IDA PAPER P-3016

# INDEPENDENT REVIEW OF THE DEVELOPMENT RISKS ASSOCIATED WITH THE COMANCHE ARMED RECONNAISSANCE HELICOPTER

August 1994

*Prepared for*  
Director, Tactical Warfare Programs

# EXISTING CONTRACTED DEVELOPMENT PROGRAM

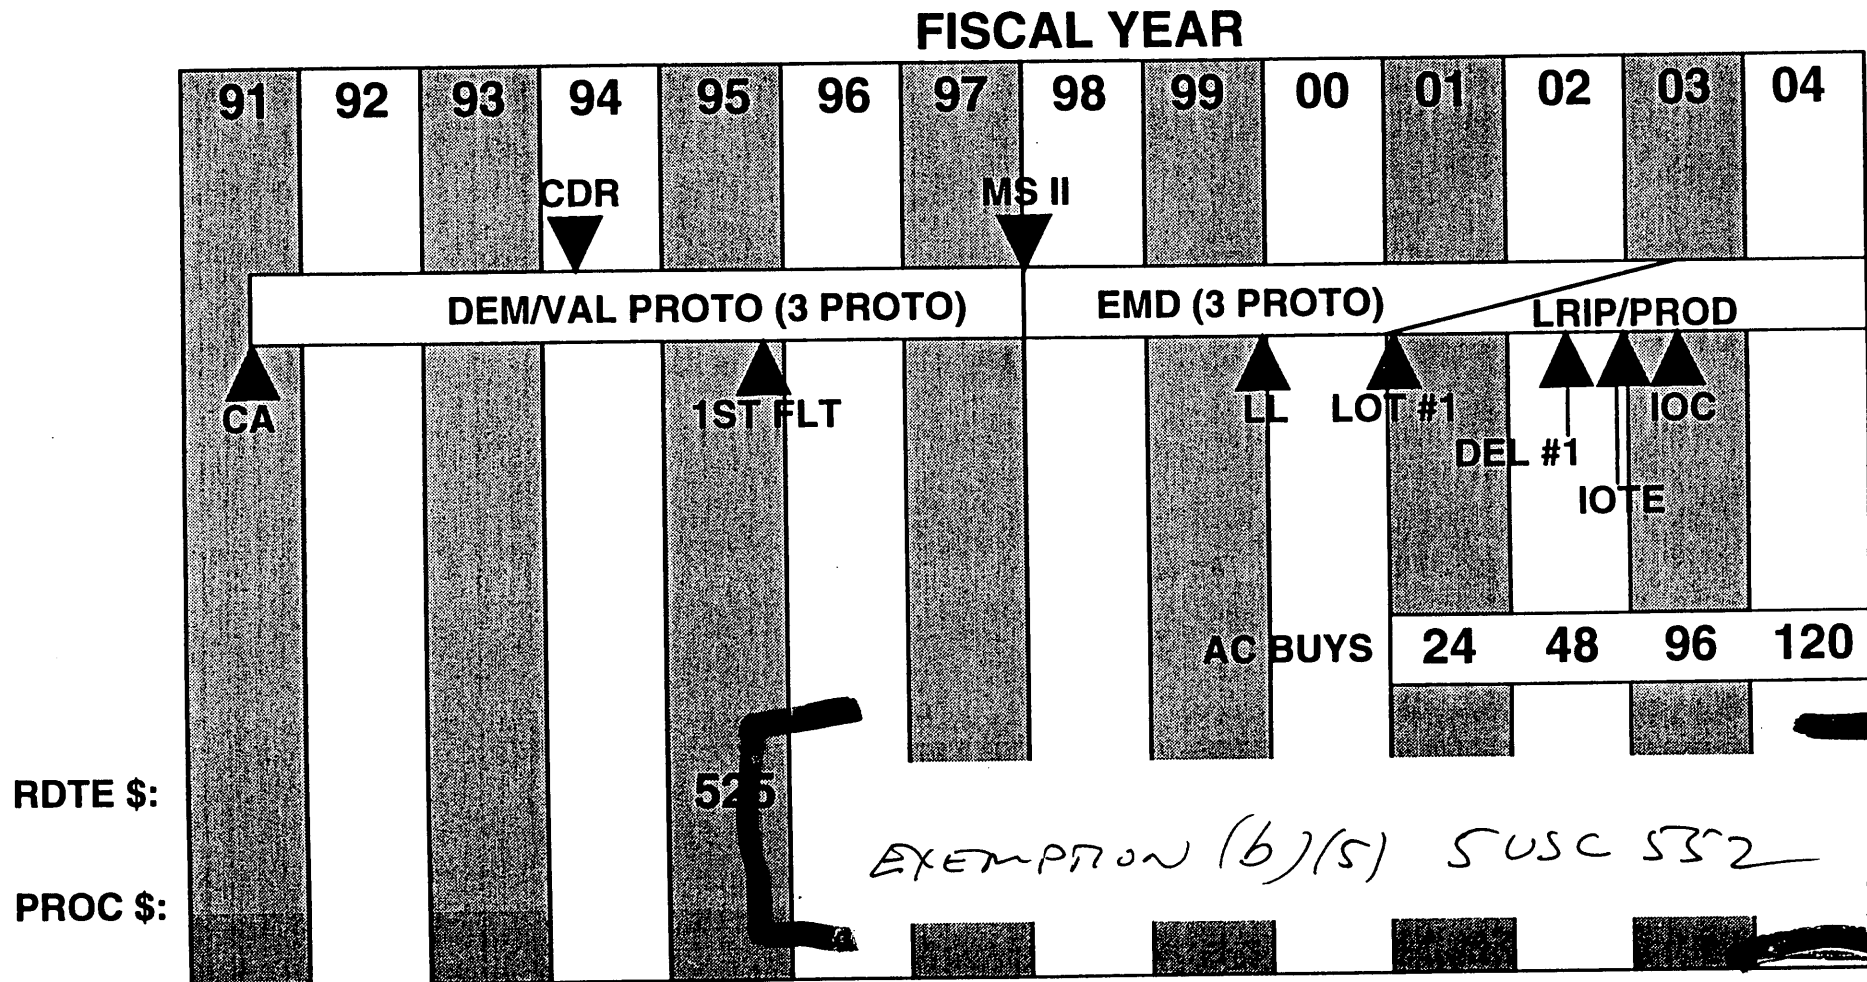
This chart shows the schedule and funding profile for the existing, contracted COMANCHE development program. Actually, only the DEM/VAL phase is currently under contract. If this development plan were continued, the Army's COMANCHE Program Office and the Boeing-Sikorsky Joint Program would soon need to begin negotiating a contract for the EMD phase of development.

As indicated on the schedule, this program features three prototype aircraft built and tested during the DEM/VAL phase, with first flight of the first COMANCHE prototype scheduled for November 1995. Three additional prototypes would be built and tested during the EMD phase. At the conclusion of DEM/VAL and prior to the award of the EMD contract, a Milestone II review would be held for the program. Long-lead production would begin at the end of FY 1999 and the first 24 production aircraft would be funded in FY 2001. Plans call for production to ramp up to 48 in FY 2002, to 96 in FY 2003, and to the full production rate of 120 per year by FY 2004. The first production aircraft would be delivered to the Army in mid FY 2002. The Initial Operational Test and Evaluation (IOTE) would be held early in FY 2003. Initial Operating Capability would be achieved by mid FY 2003.

# STREAMLINED DEVELOPMENT PROGRAM

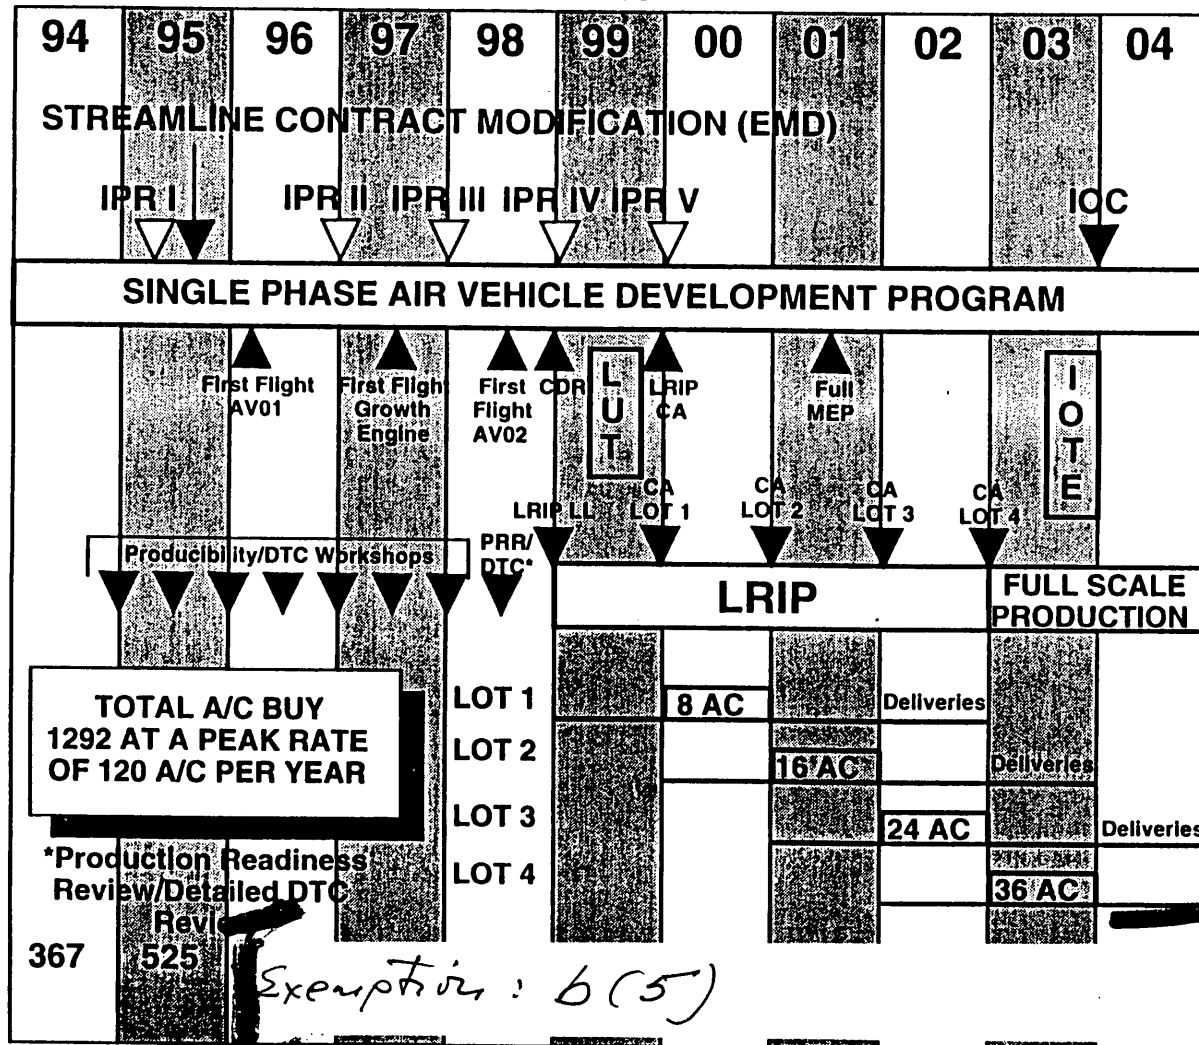
The schedule for the "streamlined" development program proposed by the Army is shown on this chart. Under this plan, in May 1995 the Army would modify the existing COMANCHE development contract to incorporate the activities normally conducted during EMD into a new single-phase development program. The first flight of the first of two DEM/VAL prototypes would occur in early FY 1996, several months later than was proposed under the existing development contract. The first flight of the second DEM/VAL prototype would not occur until late FY 1998, nearly 2 1/2 years after the first flight of the first prototype. The next three prototypes would be taken from the first lot of eight Low-Rate Initial Production (LRIP) aircraft. These prototypes would be delivered to the Army during FY 2002.

In comparison to the Army's previous plan for COMANCHE development, the "streamlined" plan initiates production one year earlier, but at a significantly slower rate. In the first year (FY 2000), only 8 aircraft would be built; in the second, 16 aircraft; in the third, 24 aircraft; and in the fourth (FY 2003), 36 aircraft.

Finally, as indicated on the chart, the funding profile for the proposed "streamlined" program is the same as is currently planned for the existing program.
